**Planning Commission
Staff Report**

Subject: Alice Claim aka Alice Lode
Subdivision & Plat Amendment
Project #: PL-08-00371
Author: Christy Alexander, AICP, Planner II

Date: April 8, 2015
Type of Item: Legislative – Subdivision & Plat Amendment

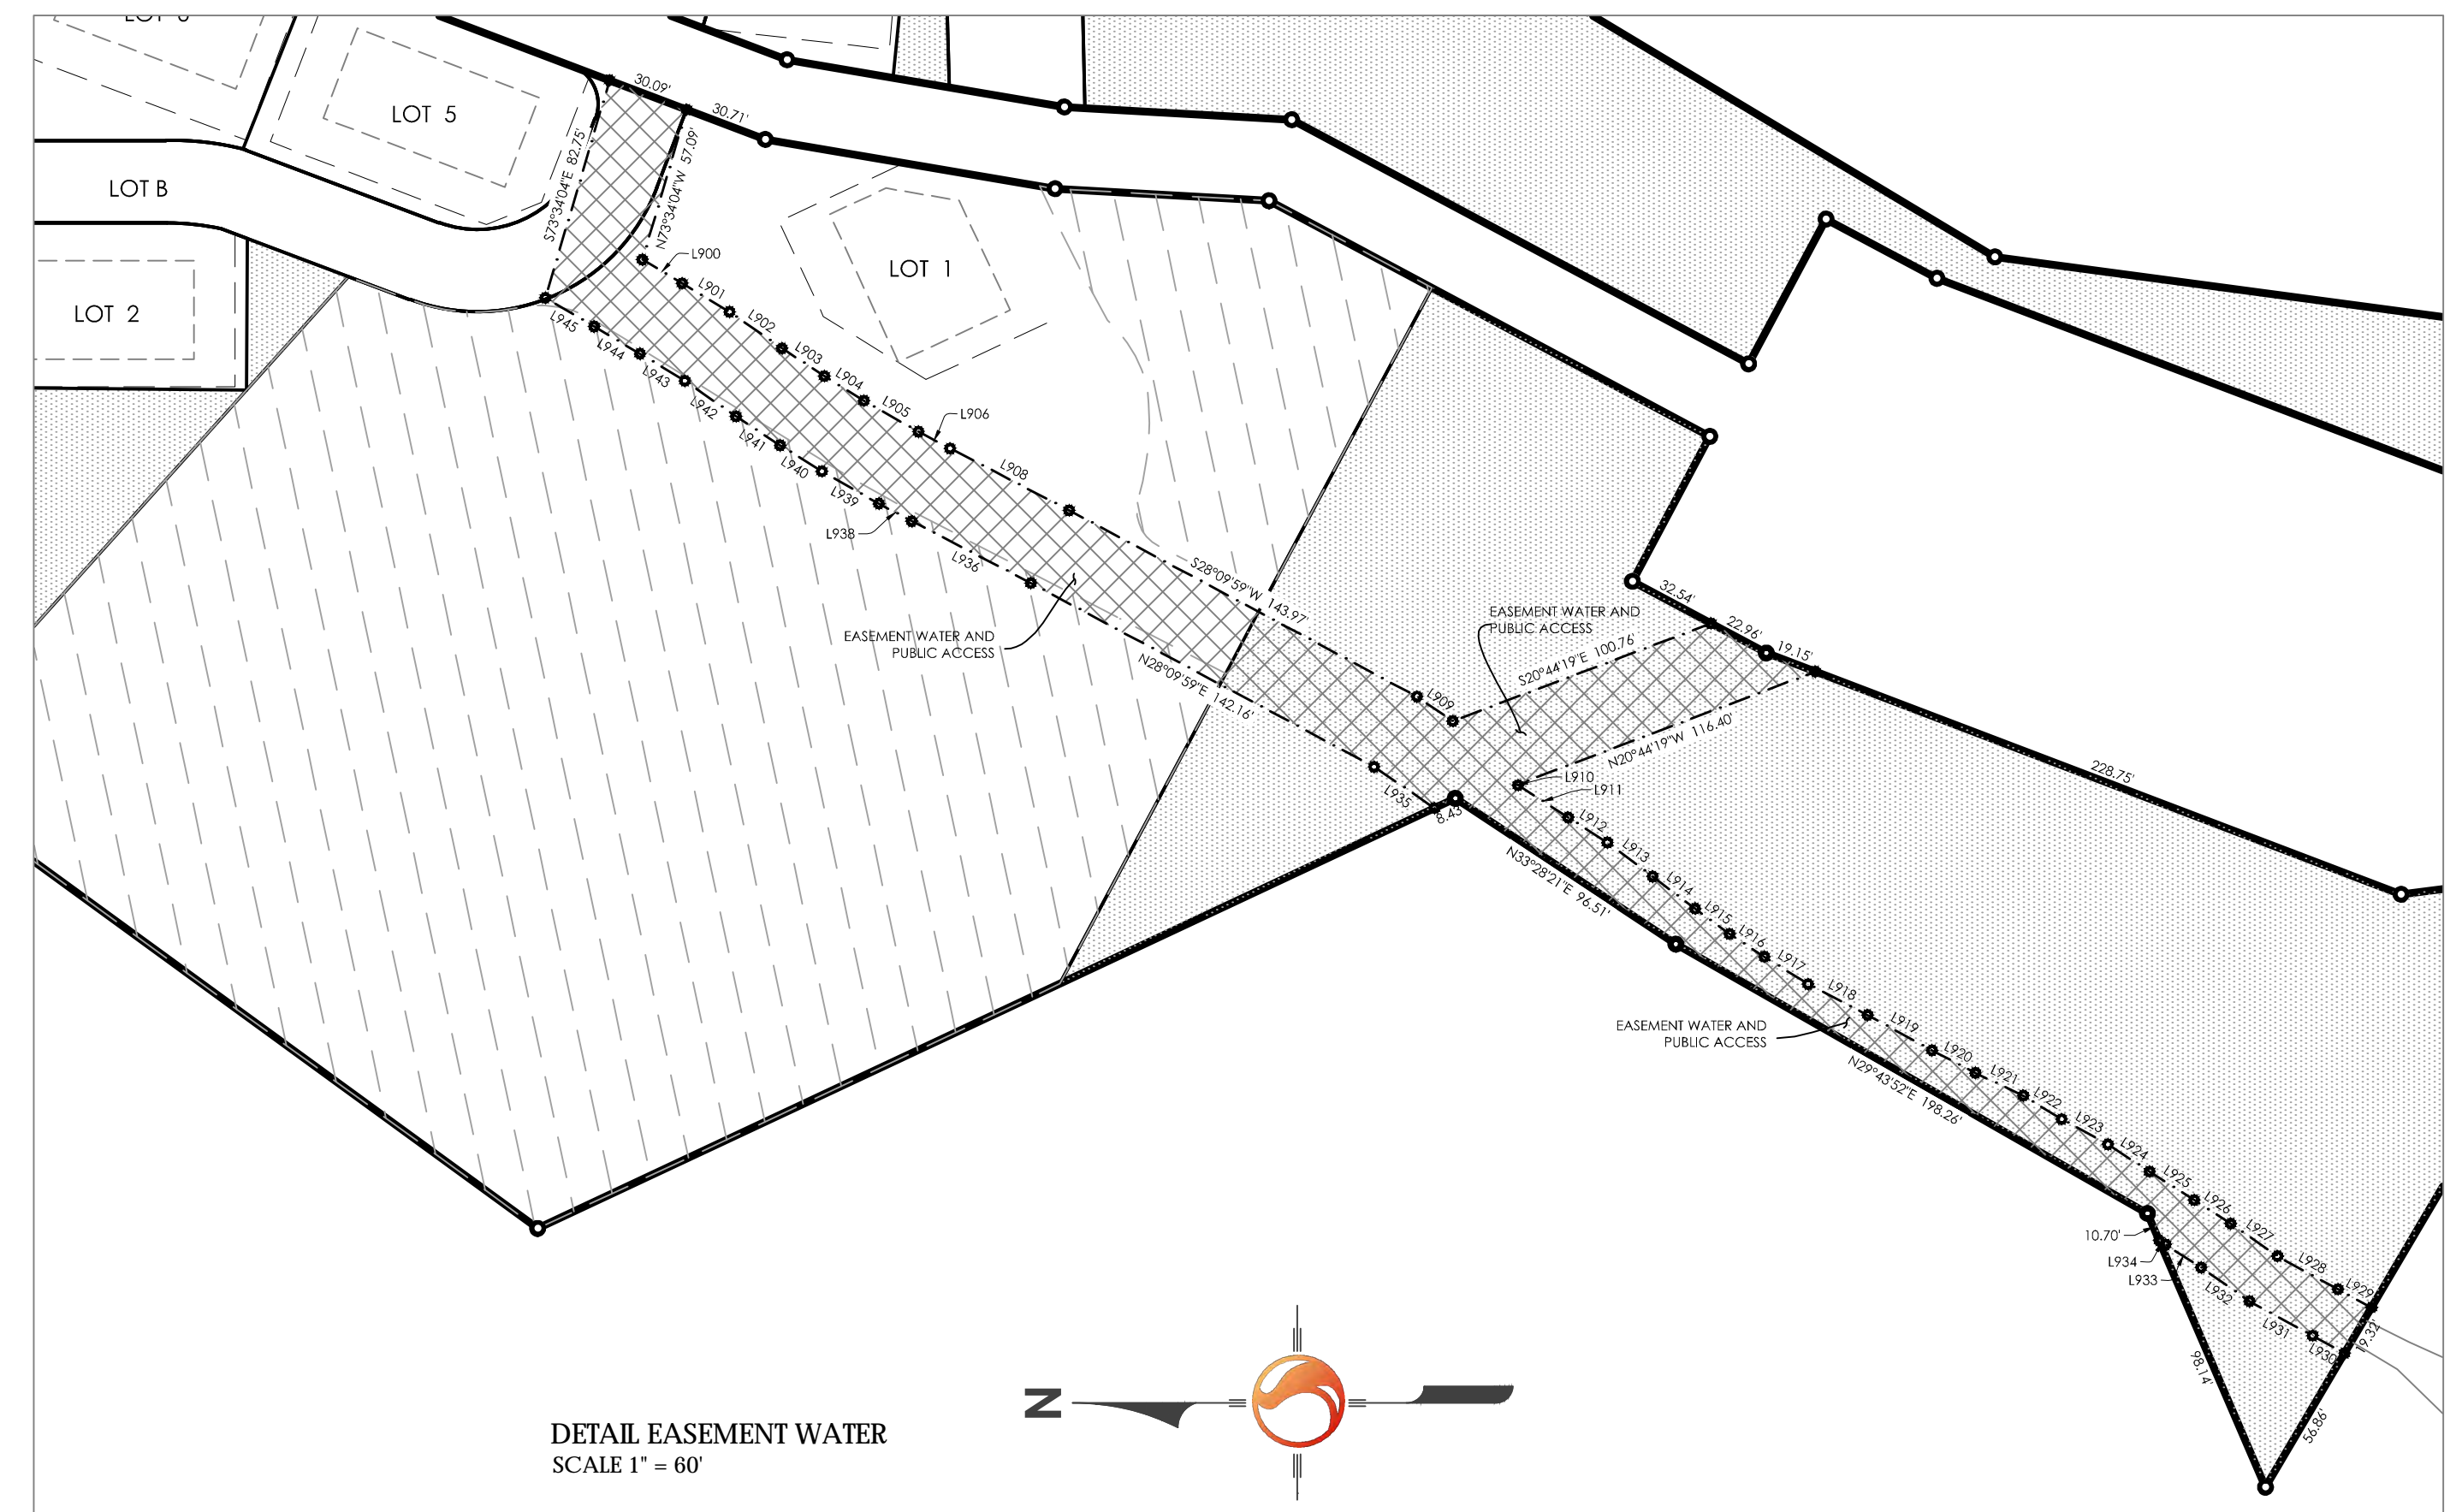
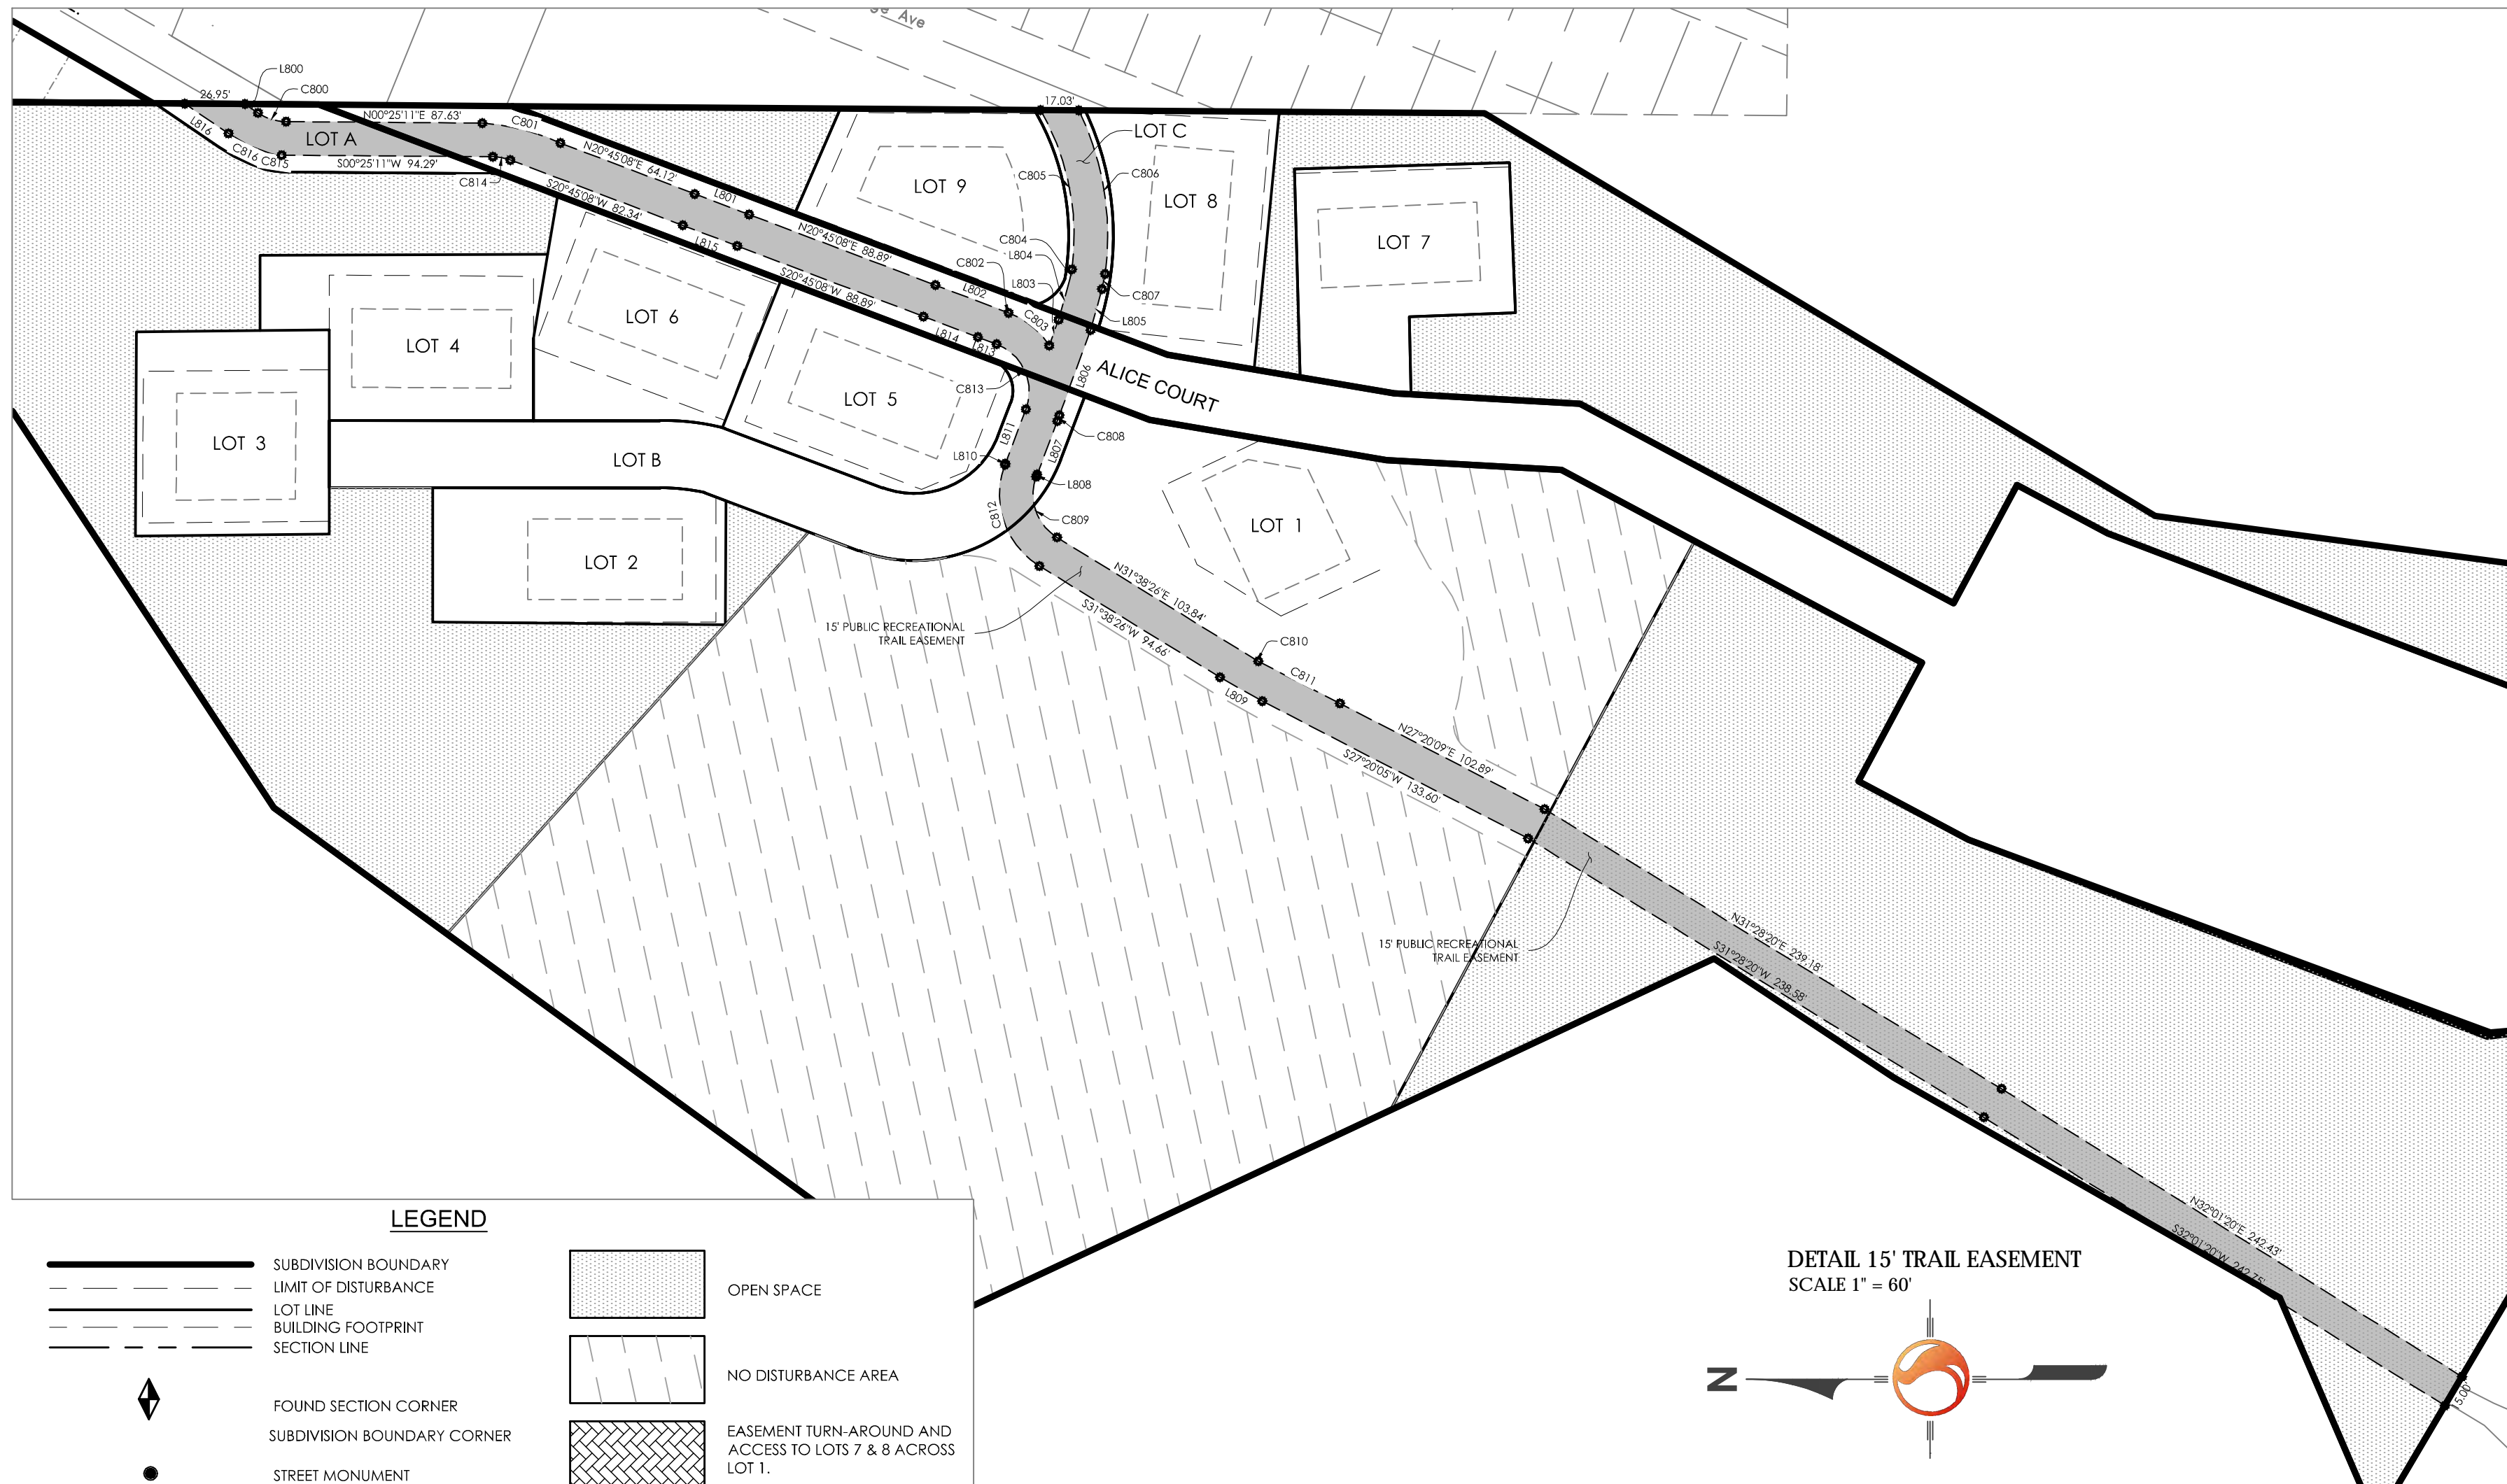
The existing City's easement for access has been revised on the plat to incorporate trails and the City's access easement changed by the Alice Court road. The Applicant will need to receive City Council's approval to give them an access over the City's property as the Applicant's drive to Lot 7 will have a crossing bridge over the City's property, which will have water lines, storm drainage, sewer, etc. (See Exhibit O). This will need to occur prior to plat recordation and has **been listed as a condition of approval.**

27. Public trails are shown on Exhibit A with a 15' public recreational trail easement.
 28. If the site plan is altered due to any utility redesign or retaining wall redesign or other unforeseen issues, this approval shall be null and void and a new application shall need to be submitted with any amendments.
